# Department of Planning, Preservation & Sustainability

## Proposed Amendments to Calhoun Street East / Cooper River Waterfront Plan Updated October 12, 2009

### 3.6 DEVELOPMENT GUIDELINES

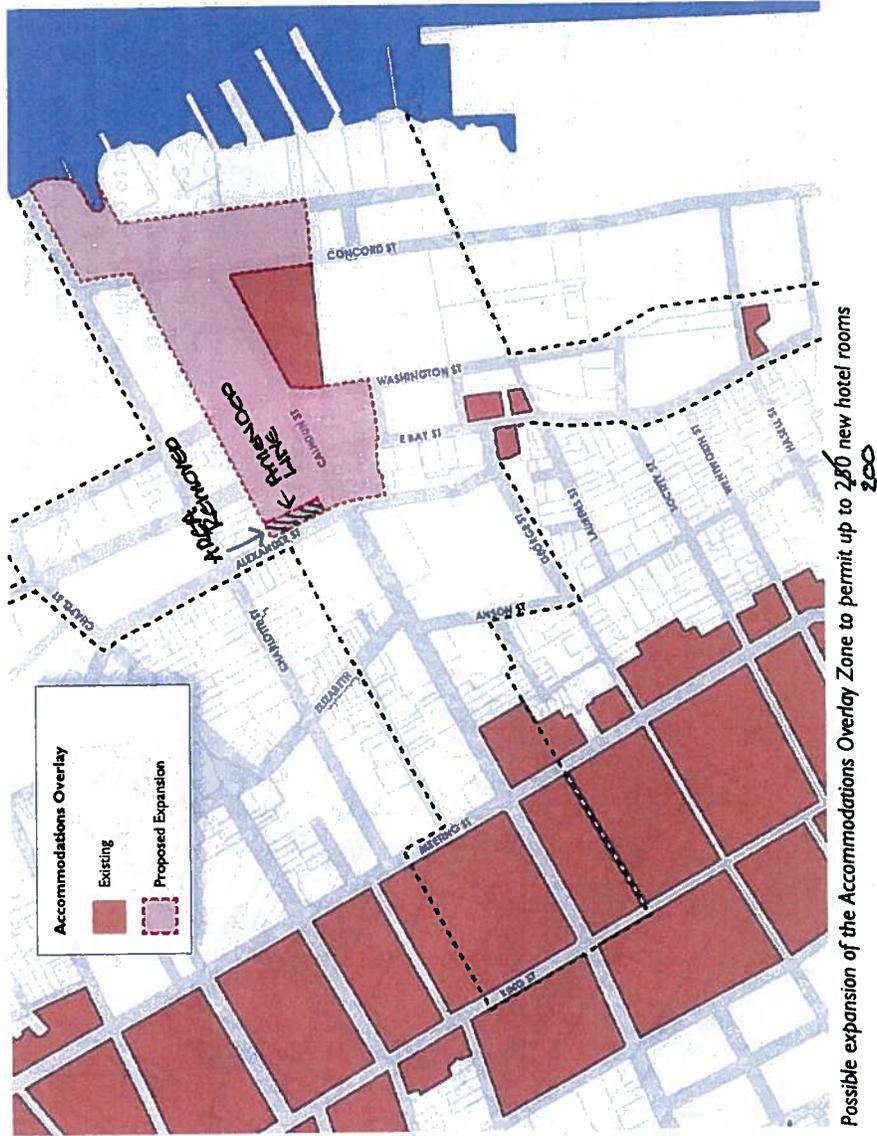
### REVISE PROPOSED ACCOMMODATIONS DISTRICT

The accommodations district will be moved away from Alexander Street allowing for 6 residential lots, strengthening the residential character of the street and lessening the impact of a hotel. No hotel access will be allowed on Alexander or Charlotte Street.

*The maps and text on p. 35 and p. 60 will reflect the amended boundary per the attached map. A statement will be added to p. 60 that no hotel access will be allowed on Alexander or Charlotte Street for a hotel in this block.*

# 55' height zone (Calhoun St)

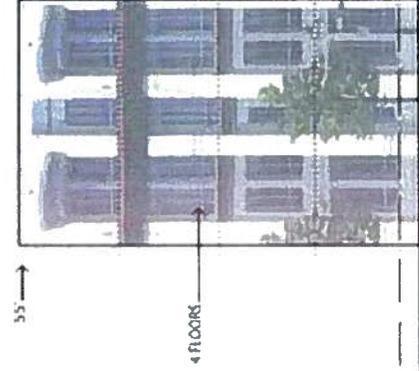
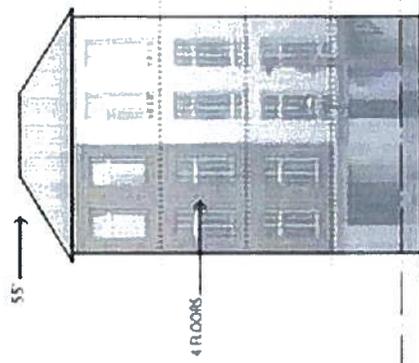
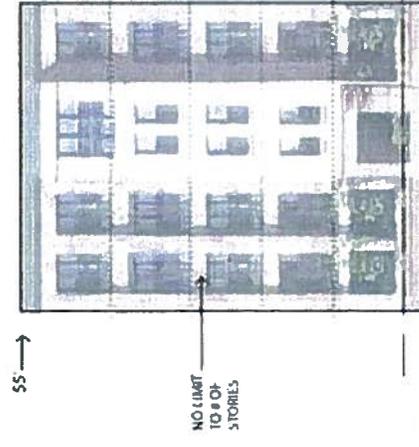
### CLARIFY HEIGHT/STORY ILLUSTRATIONS

The intent of the plan is to maintain the maximum heights currently in place in the zoning ordinance. For example, a four story building would not exceed 55', the current standard.

*The illustration in Section 3.6 on page 63 of the plan will be revised to better explain the intent of the plan. (see attached)*

= 55' and max 4 floors
